SOUTH BEND TACKLE COMPANY, INC.

SUPPLEMENTAL SERVICE BULLETIN #5-1

March 9, 1964

Subject: Sea-Matic Reel #808

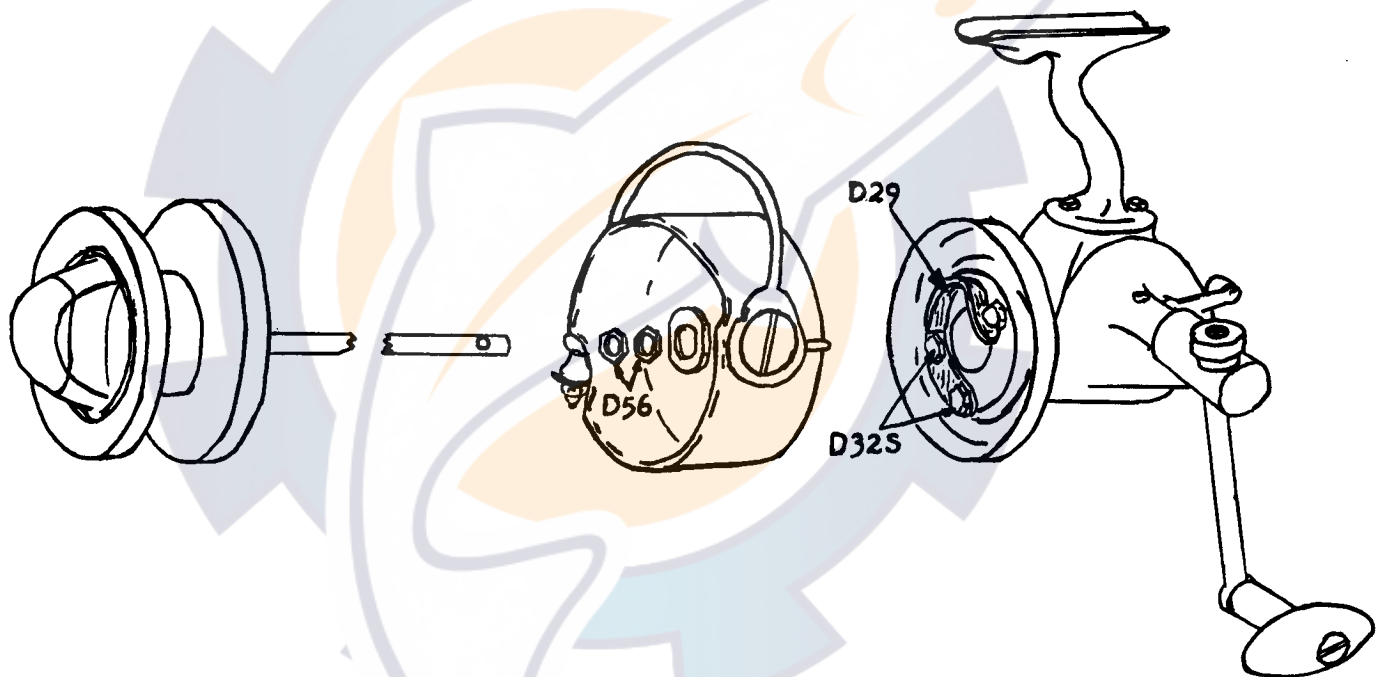
Condition: Under hard surf casting, the inertia of a hard cast may occasionally trip the bail during the cast.

Correction: Install D29 Bail Trip Brake with D32S Bearing Cover Screws.

- Procedure:
1. Remove cover plate
  2. Remove level wind yoke screw
  3. Remove spool and main shaft
  4. Remove pickup housing nuts D56 and complete pickup sub assembly.
  5. Remove and destroy bearing cover screws D32S
  6. Install Bail Trip Brake using new bearing cover screws enclosed with Bail Trip Brake.
  7. Re-assemble in reverse order.
